Technical Specification
Page Revisions

Consolidated Edison Company of New York, Inc.
Indian Point Unit No. 2
Docket No. 50-247
March, 1987

Safety Assessment

Loss of Normal Feedwater Analysis

Figure 14.1-51 A
Loss of Normal Feedwater with 300 gpm
Auxiliary Feedwater

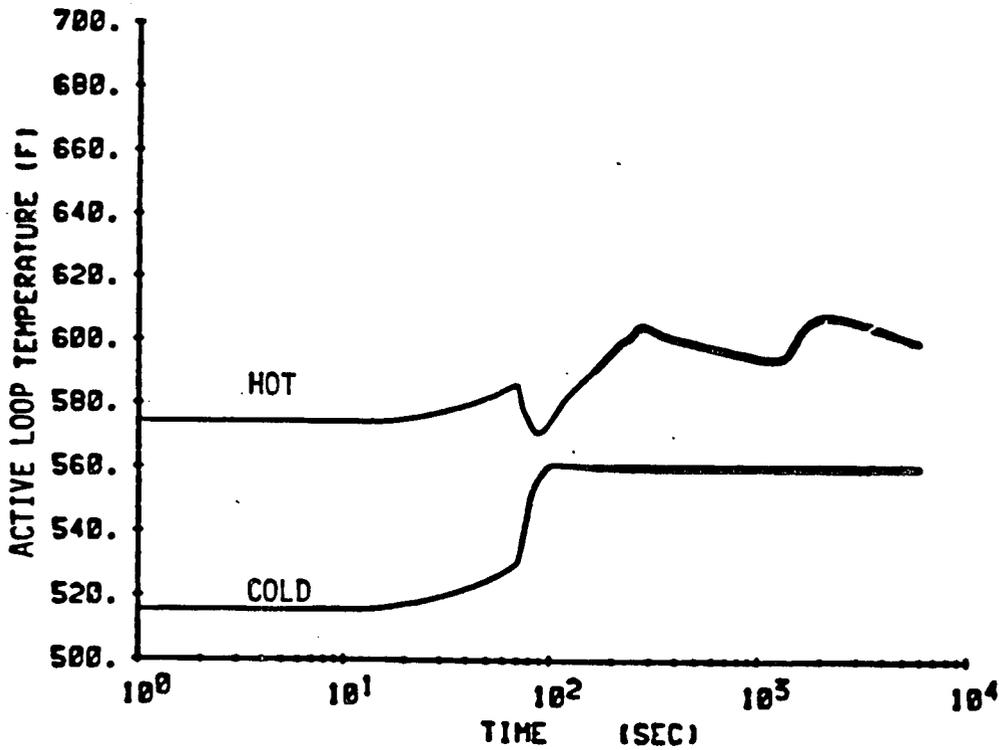
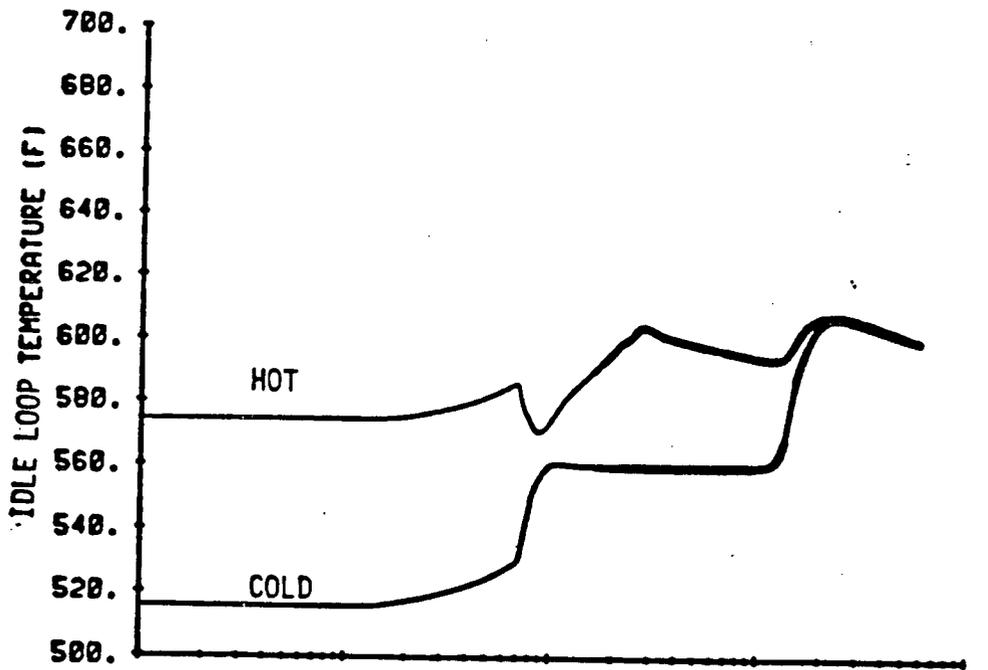
Figures 14.1-51 A, B and C show the plant parameters following a loss-of normal feedwater accident with the assumptions listed above. Following the reactor and turbine trip from full load, the water level in the steam generator will fall because of the reduction of steam generator void fraction and because steam flow continues to dissipate the stored and generated heat. One minute following the beginning of the accident the auxiliary feedwater pump is automatically started, reducing the rate of water-level decrease. The capacity of the auxiliary feedwater pump is such that the water-level in the steam generators being fed does not recede below the lowest level at which sufficient heat transfer area is available to dissipate core residual heat without water relief from the primary system relief or safety valves.

From Figure 14.1-51A it can be seen that at no time is there water relief from the pressurizer. The assumption of more auxiliary feedwater capacity than that of one motor-driven pump or that the initial water level of one steam generator is above the low-low level trip level will of course result in increased margin to the point at which reactor coolant water relief could occur.

The results presented are for a reanalysis of the loss-of-normal-feedwater transient, which accounts for the current power rating (2758 MWt), and a constant auxiliary feedwater flow rate of 300 gpm.
